**US 411 Connector  
Project EDS-500(5)  
Bartow County  
P.I. NO. 661950**

**TECHNICAL MEMORANDUM**

DATE: September 11, 2008  
TO: EDS-500(5) Project File  
FROM: GDOT, with revisions by FHWA  
SUBJECT: Alternative D-VE Evaluation

Figure 2 US 411 / I-75 Interchange (Part 1)

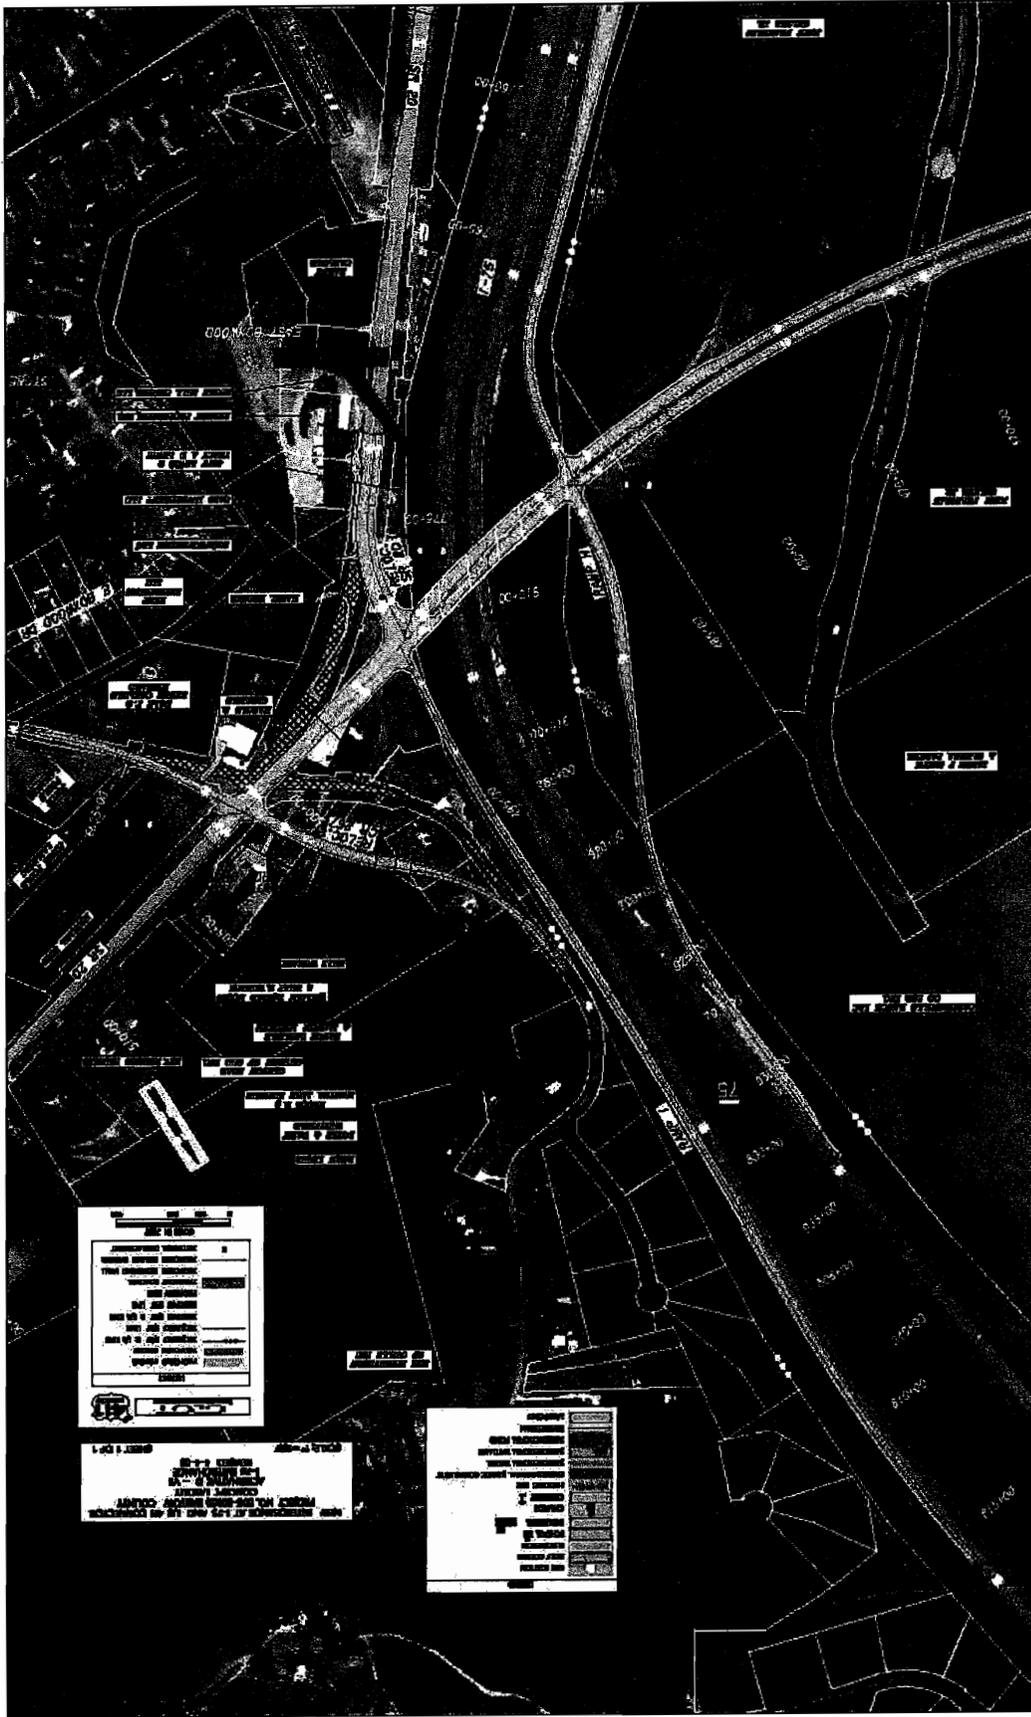
**Figure 2** illustrates the I-75/US 411 Connector interchange configuration. Because the Alternative D-VE route from northbound I-75 to westbound US 411 Connector is longer and has more signalized intersections to traverse than does the Alternative D-Avoidance/Minimization route, travel time from the I-75/SR 20 Interchange to the US 411 Connector/US 41 Interchange will be longer for Alternative D-VE than for Alternative D-Avoidance/Minimization. As shown in **Table 11**, 2030 p.m. peak hour travel time for this primary I-75-to-US 411 West traffic flow will be significantly better with Alternative D-VE than it will be for the No-Build Alternative (8.7 min vs. 15.8 min), but it also will be somewhat slower than for Alternative D-Avoidance/Minimization (8.7 min vs. 7.2 min).

Figure 1: I-75/US 411 Connector/SR 20 Interchange Configuration

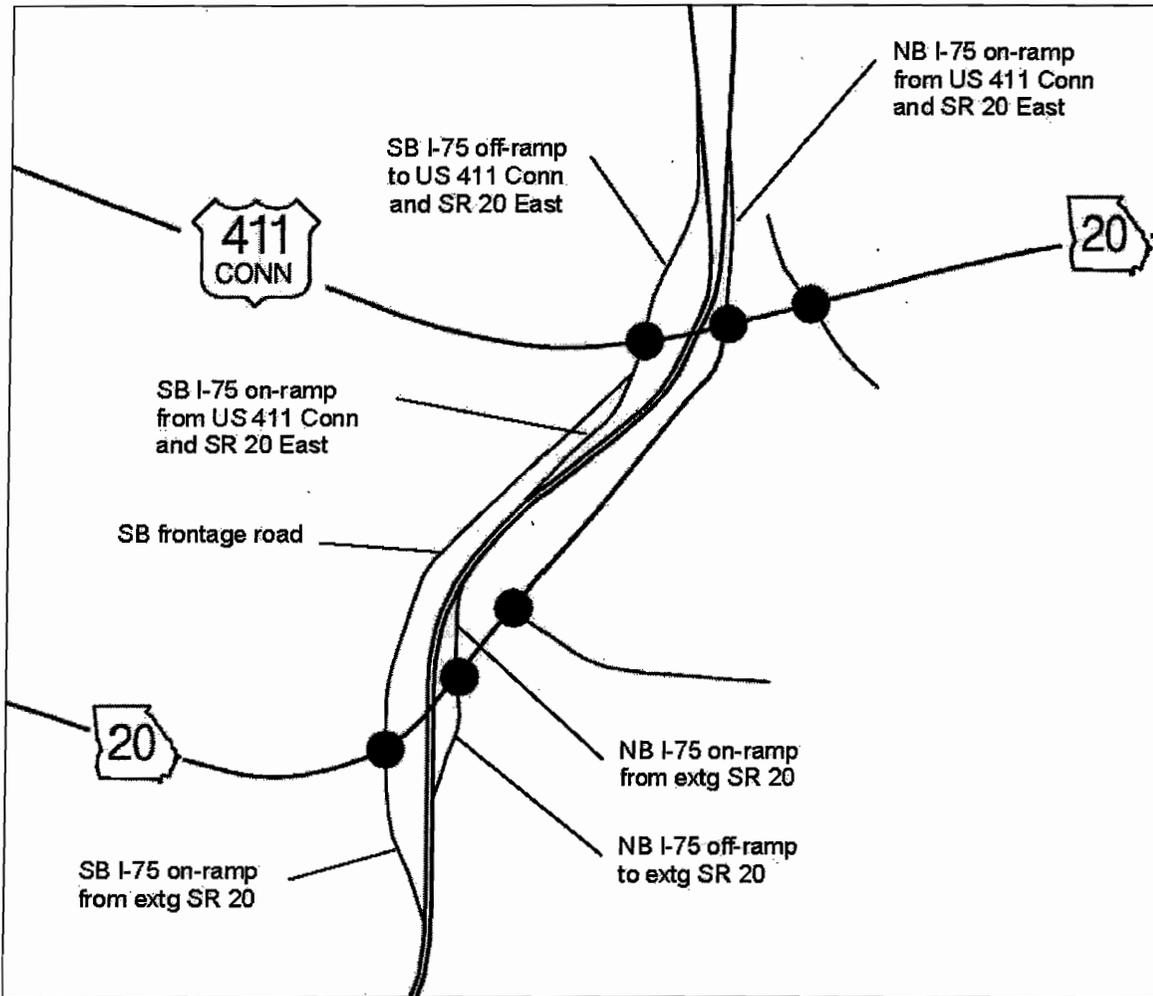
The proposed Alternative D-VE new/modified interstate access is located on I-75 north of the existing SR 20 interchange, as shown in **Figure 1**. The new/modified access comprises the following elements:

- 3/4-diamond at US 411 Connector–SR 20 E. (There is no I-75 NB off-ramp: the connection from NB I-75 to US 411 Conn [WB] is via the existing SR 20 off-ramp, a one-mile EB segment of existing SR 20, and a left turn at the signalized US 411 Conn/NB I-75 ramp terminal intersection.)
- 3/4-diamond at existing SR 20. (There is no SB off-ramp: the connection from SB I-75 to SR 20 W is via the US 411 Conn off-ramp and a one-way SB frontage road to the signalized SR 20 W/SB I-75 ramp terminal intersection.)
- The US411 Connector links directly to the east-west segment of existing SR 20 on the east side of I-75; existing SR 20 to/from the west/south “tees” in at the signalized NB I-75 on-ramp terminal intersection.

Figure 2: 2034 P.M. Peak Hour Intersection Traffic Volumes

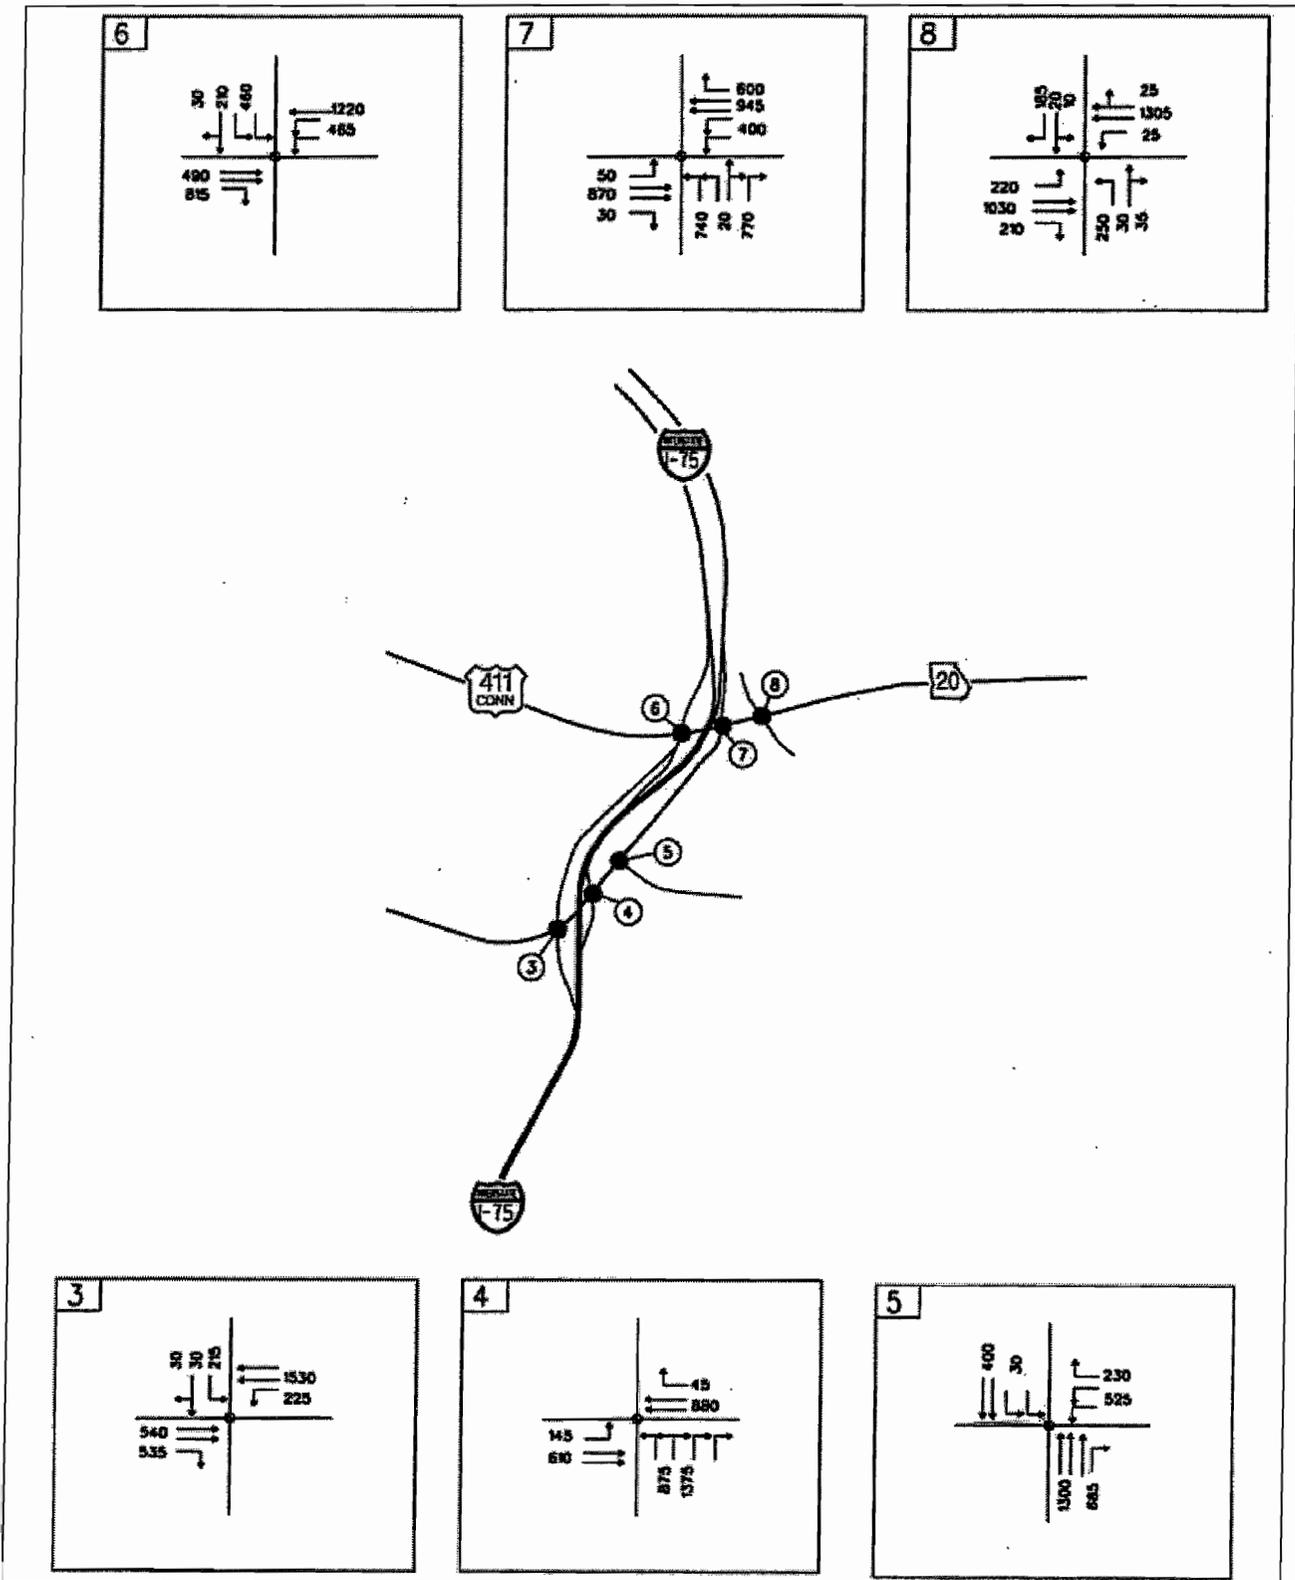
- The specific intersection lane configurations necessary to support adequate LOS and queuing conditions were identified (these lane configurations are shown in the peak hour intersection volume diagrams (see **Figure 2** and **Figure 4**).
